ADDENDUM NO: 1

PROJECT: **SITE IMPROVEMENTS AT FRANKLIN CENTRAL JUNIOR HIGH**

CONTEXT PROJECT NO: 22-1613 DATE: 2/13/2024 BY: Fred Prazeau

Sheet No:
L301

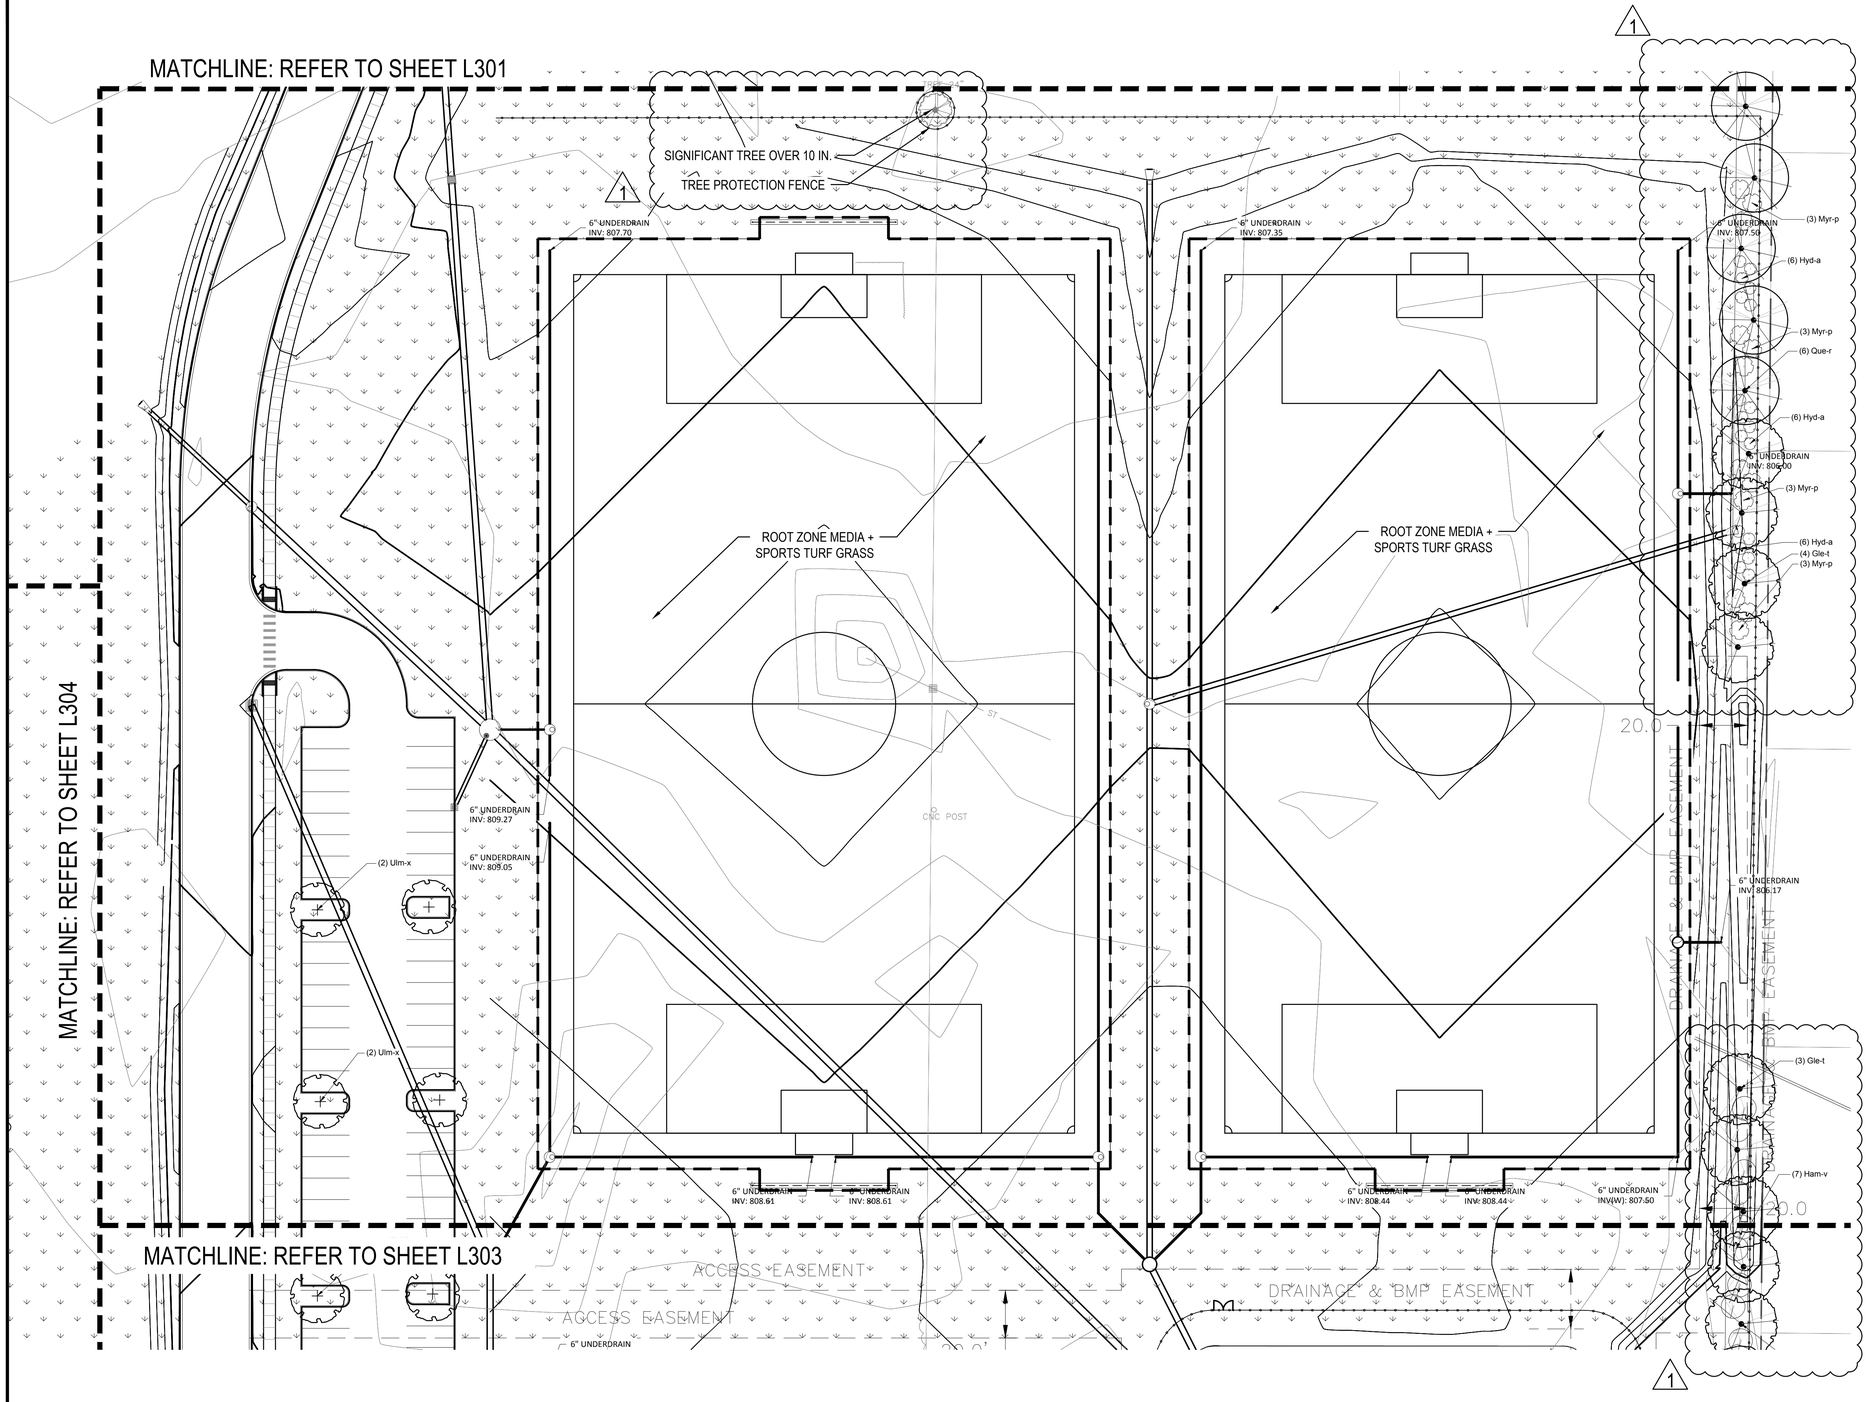
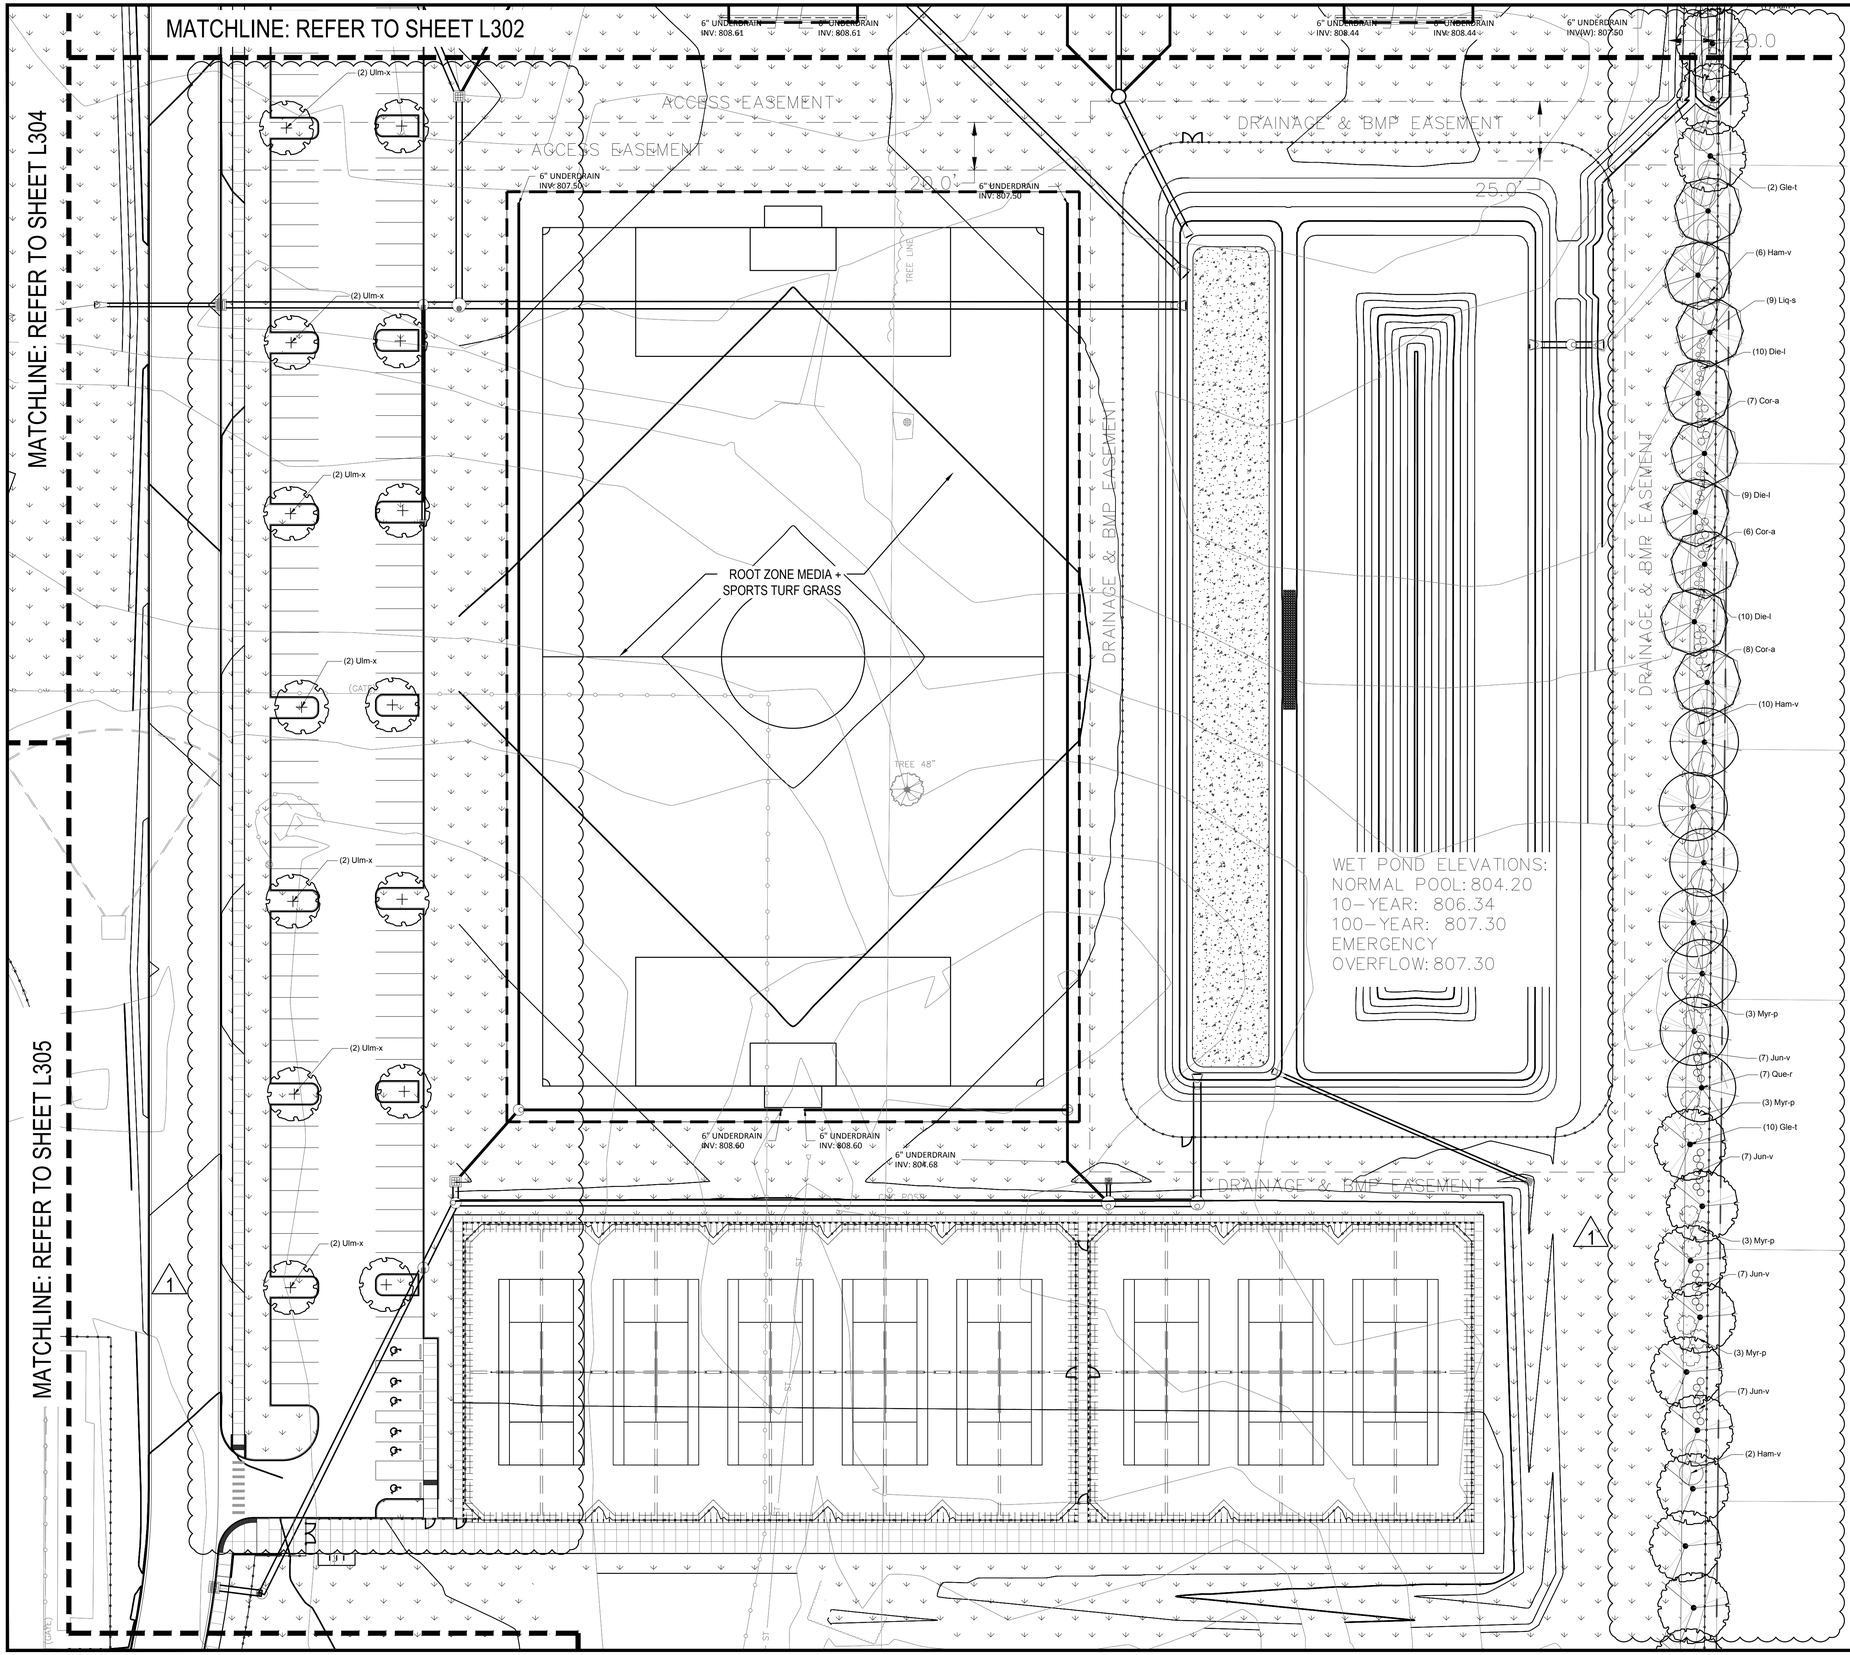
1. L100-Series Material Identification Plans reissued to address City comments, including clarifications to curb ramps, crosswalks, tree protection (single tree), soccer parking islands, and bike racks.
2. L300-Series Landscape Plans reissued to address City comments, including additional landscape planting, parking lot islands, and tree protection (single tree). Sheet L310 added.
